Port Macquarie Southern Breakwall Upgrade

Submissions Report
November 2022

Figure 3: Image depicting the Tree Protection Zone (TPZ) and Structural Root Zones (SRZ) found in the Tree Impact Assessment.

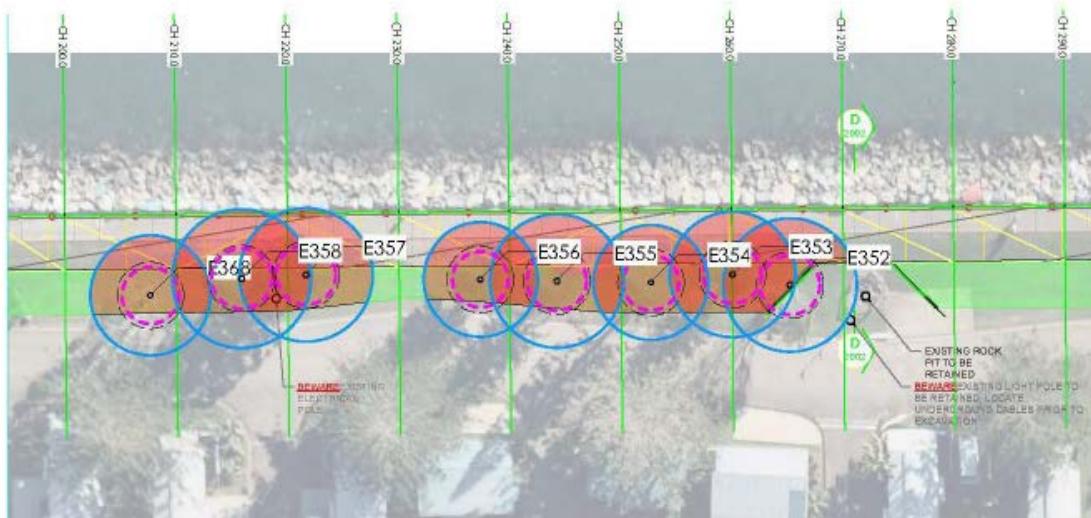
- 192 submissions opposed the removal of Norfolk Island Pines
- 52 submissions suggested reducing the width of the footpath to retain the trees (see section 3.3 for response)
- 22 submissions supported and understood the need for the removal of trees for the proposal
- 15 submissions said that it was a shame to remove the trees and, if possible, they should be retained
- 8 submissions said that a five-metre path would fit, saying there is no need to remove the trees.

Following community feedback, a further Tree Impact Assessment was carried out. It investigated and calculated the Tree Protection Zones (TPZs) and Structural Root Zones (SRZs) in accordance with the Australian Standards for Protection of trees on development sites.

Figure 8: Example from Landscape Plan

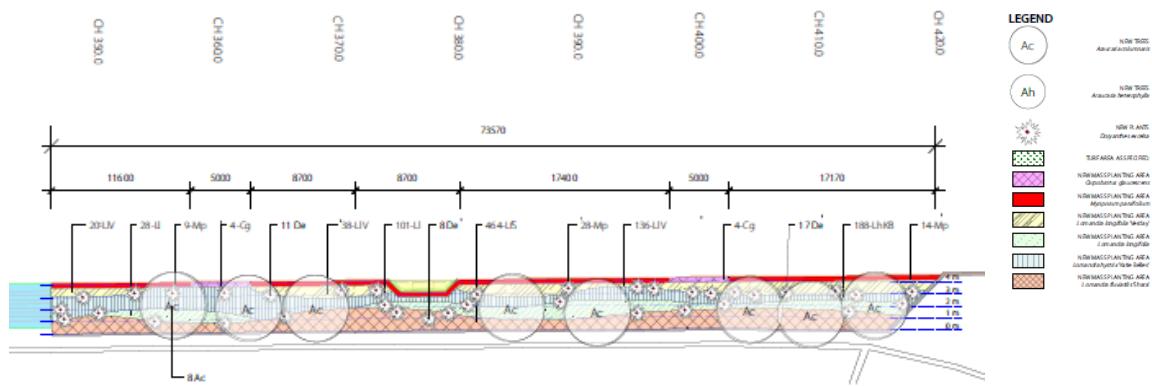
- 15 submissions noted that it takes too long to regrow to their current size.
- 13 submissions would prefer to see native trees instead of Norfolk Island Pine trees
- 12 submissions requested that they be replaced with Norfolk Island Pine trees
- 7 submissions were of the view that replacing trees is not an adequate response
- 1 submission asked us to consider tree relocation

The Landscape Plan will feature the following replacement trees:

- 39 Cook Pines – three-year-old, mature trees of three to four metres in height
- 4 Norfolk Island Pines – three-year-old, mature trees of three to four metres in height

Figure 12: Proposal drawing demonstrating the widening of the footpath in yellow.

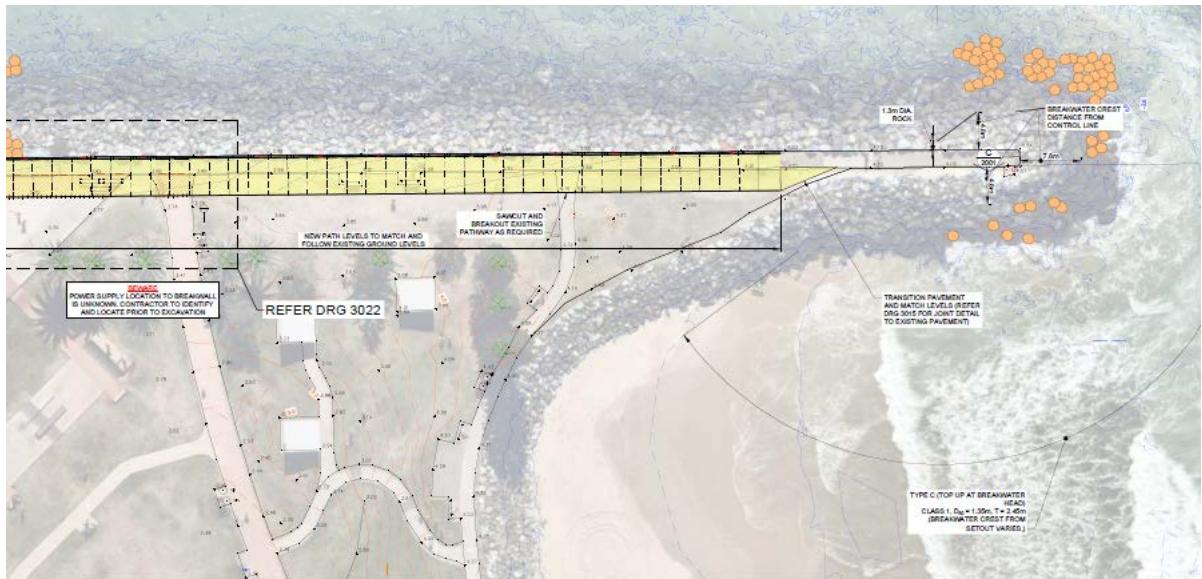
Response

To reduce any impacts to surf conditions, Transport is not increasing the width of the footpath or the footprint of the southern breakwall head.

The five-metre-wide shared user path does extend past the skate park and connects to the two other Council footpaths at Town Beach area, making it accessible for people with mobility issues who can park at the Town Beach car park.

Figure 16: Breakwall head pre and post repair

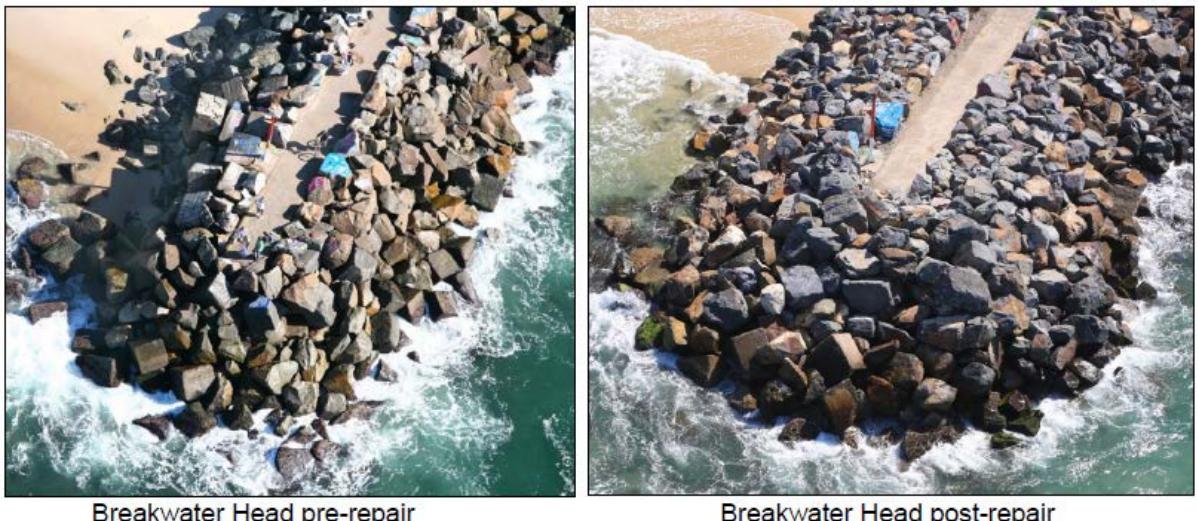
- 74 submission expressed concerns that the work could impact, change, or destroy the surf break
- 27 submissions detailed concerns that the proposal could impact the flow of sand and tide run out which could impact the surf break.
- 8 submissions showed that they understand that the maintenance work proposed at the head is minimal and would not impact surf. They also acknowledge that the surf break is created by the breakwall and that the breakwall needs to be maintained.

The below image clearly demonstrates that the breakwall head had suffered damage and was inadequate to meet wave climate requirements. If this was left to deteriorate further, a major failure was highly likely. So, in 2014, major maintenance work saw 1800 tonnes of rock added to the breakwall head to maintain its integrity.

Figure 13: Extent of Breakwall head indicating areas of damage requiring remediation in green.

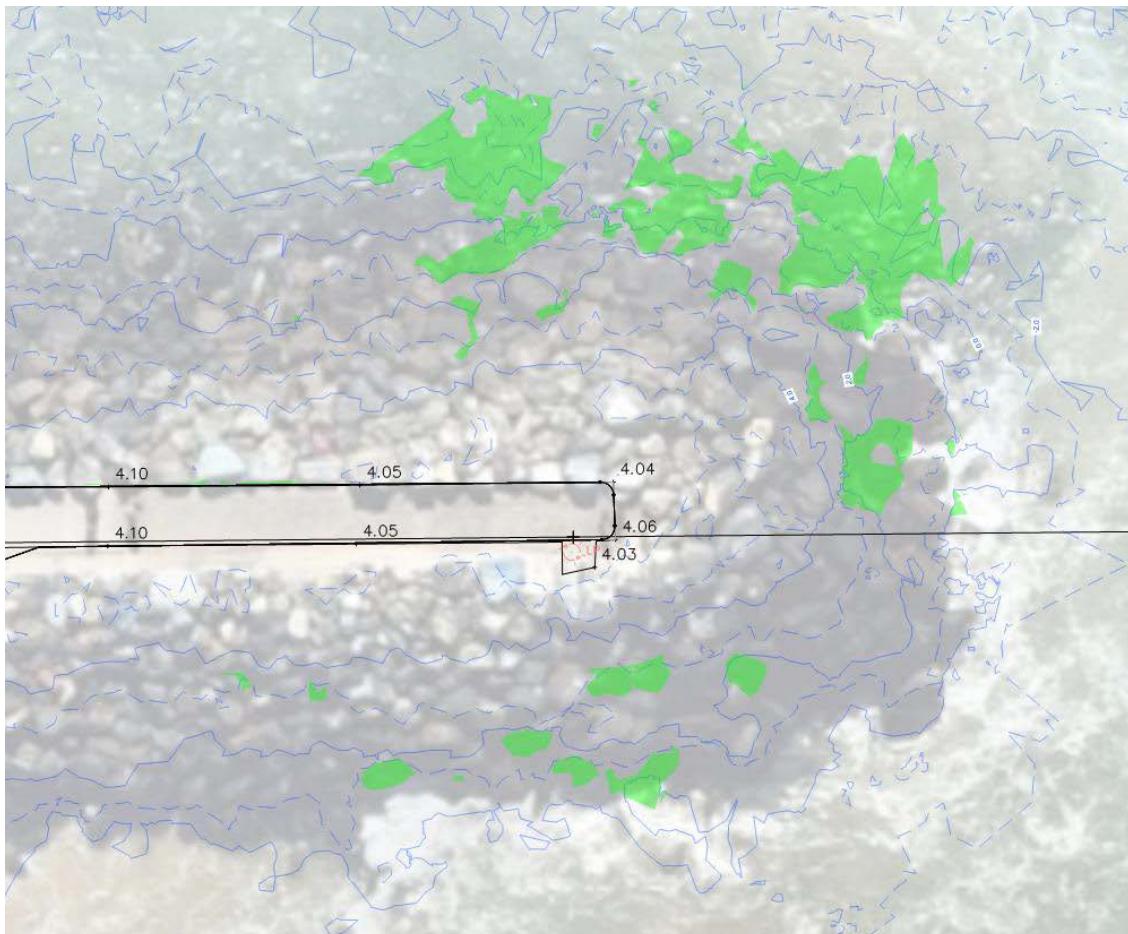
- However, specific areas of damage (see Figure 13 below) were identified that included the movement and displacement of individual armour units from the primary armour layer such that voids in the layer have opened and/or an oversteepening of the layer has occurred producing areas of instability in the structure.

- Individual armour units are proposed to be placed where voids have opened and oversteepening has occurred due to armour rock movements since the previous remediation work.

- Failure to remediate this damage will leave the breakwall head vulnerable to progressively greater damage over time or potential failure; and
- The placement of the individual armour units at the head is required to restore the breakwall profile and armour thickness, to the previously installed extents which satisfy the overall design intent of the structure.

Figure 14: Cross sections in the detailed drawings indicating rock placement at the head including in the Draft REF

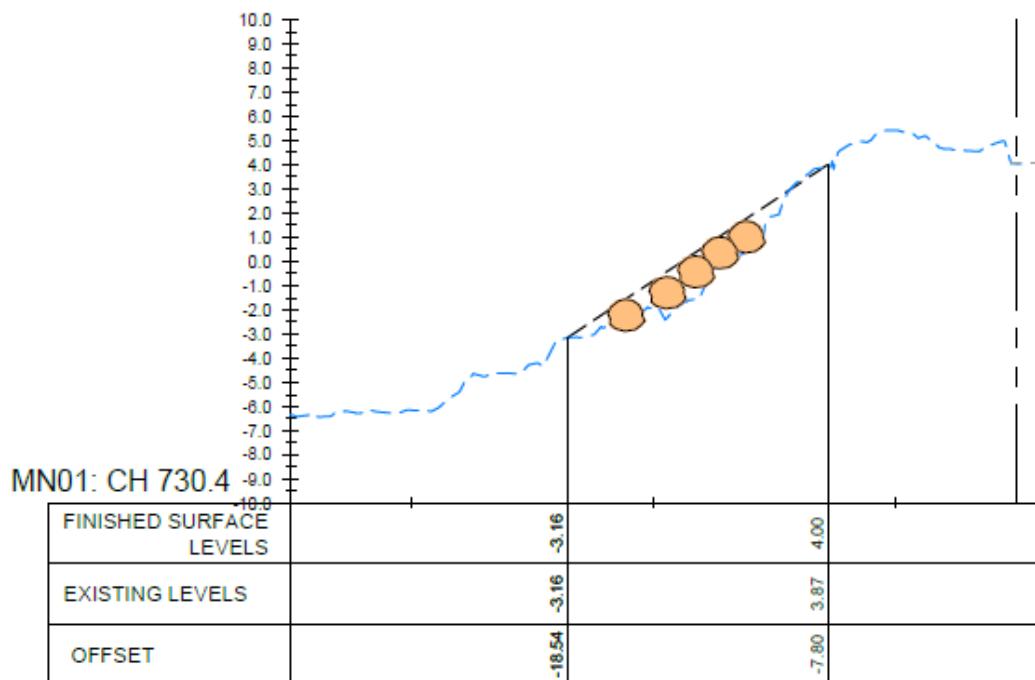
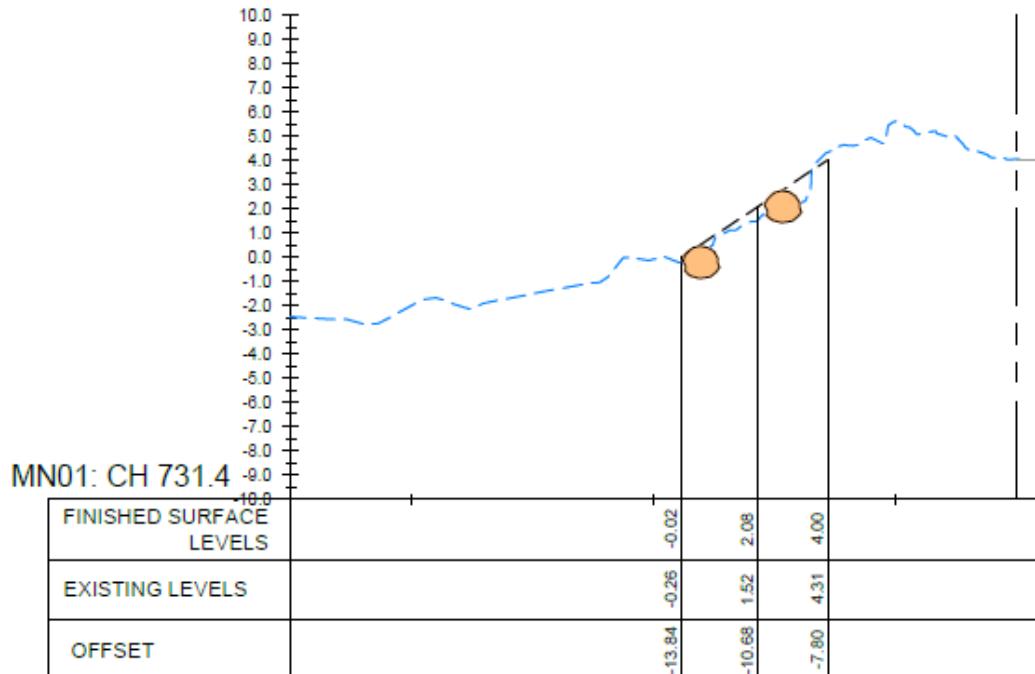
- 65 submissions expressed the view that the work proposed would create a “mushroom head” at the breakwall head which will impact the surf break. They say that they do not want to see any change to the shape of the breakwall head or rock added at the breakwall head.
- 4 submissions expressed the view that the proposal is extending the breakwall

It is not intended to increase the southern breakwall extent beyond that of the original design intent of the 2014 remediation works. Accordingly, there will be no discernible change to the hydrodynamic response (waves, tides, currents) and associated sediment transport processes at the breakwater head relative to that which has existed since the 2014 remediation works.

This information was detailed in the REF in Appendix A –*Plans of Proposal*, specifically in the breakwater cross section, sheet 11. It shows the current profile of the breakwall, from the multi-beam bathymetry and drone photogrammetry, and the areas of individual armour rocks that need to be replaced.

Figure 18: Cross section of breakwall crest, path, and batter

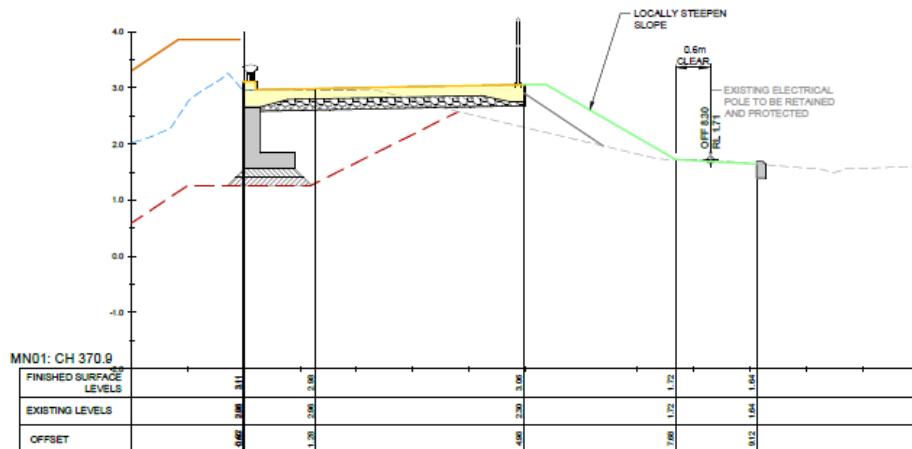
Response:

1. Safety-in-design requirements were assessed as part of developing the proposal. The handrail fence was included as a safety measure to reduce the risk of pedestrians and cyclists falling down the new steeper batter.
2. Widening the shared user path will create a steeper batter. The batter will also be more heavily vegetated.

The below image shows the current ground slope profile (batter) as indicated in the grey dotted line and the new steeper ground slope profile in the darker grey line. The new slope falls away from the fence barrier with no room for people to stand to the side of the footpath as there will be no flat ground available here.

Figure 21: Cross section from draft REF, shows current and predicted height of rocks after construction.

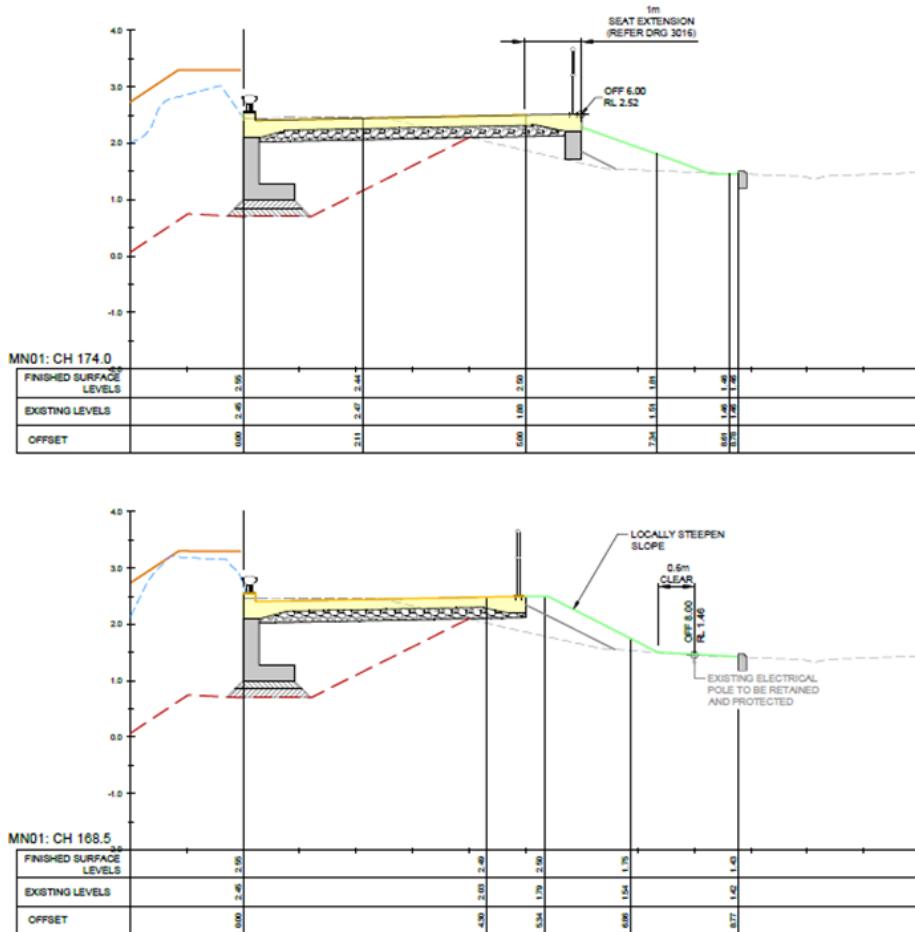
It is expected the rocks along the footpath will sit just under one metre in height from the shared user path. East towards the breakwall head this may be a little higher than a metre to meet the breakwall seaward end guidelines and to protect users of the shared path from wave surges.

In the image below, the blue dash line shows the current rock height, and the orange line shows what the rock height will be after the work is finished. This varies because the current height of the rocks is not consistent along the entire southern breakwall because of its poor condition and because of slumping of rocks.

Figure 24: The proposal map has been updated to reflect the Landscape Plan

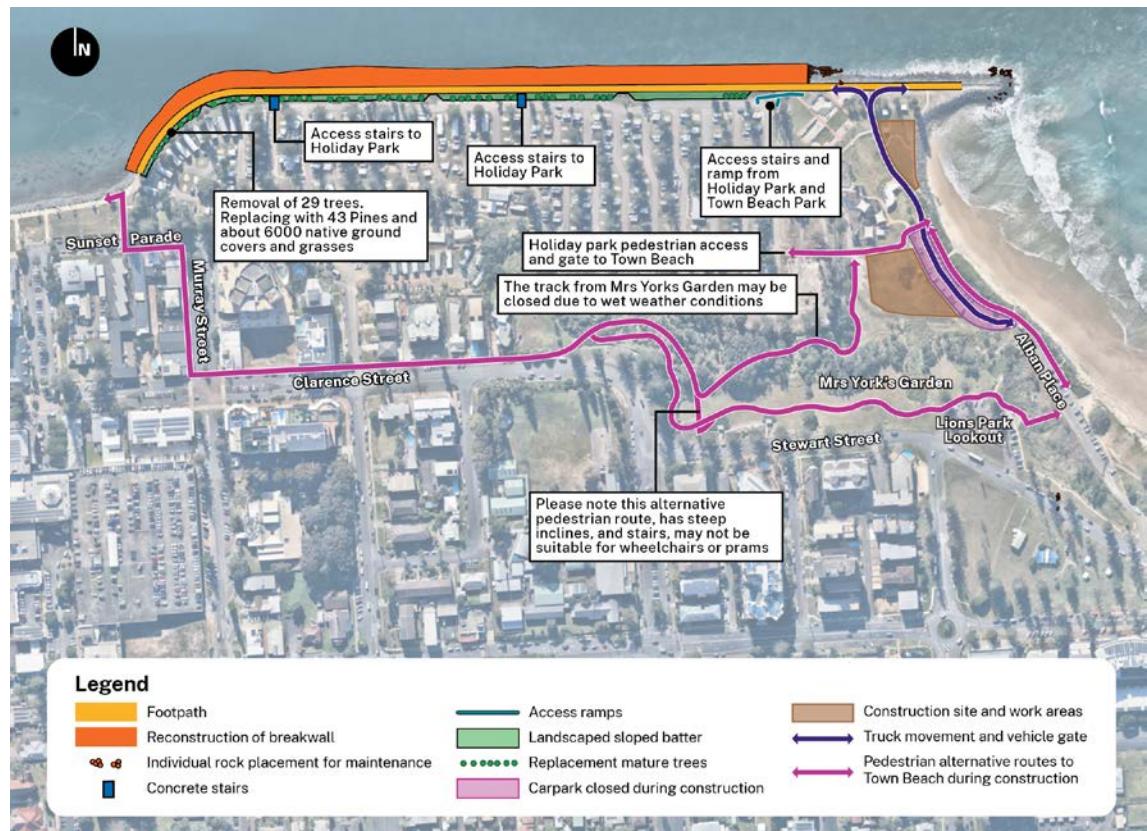
As a result of community feedback during the submission period and the display of both the draft REF and the concept design, Transport has incorporated the following changes to the proposal.

Committed		More replacement planting	Committed		Informal safety stairs in breakwall	Available now		Additional assessment information
Committed		Solar bollard lighting	Investigate		Improve shared path safety	Committed		Work to start in May 2023
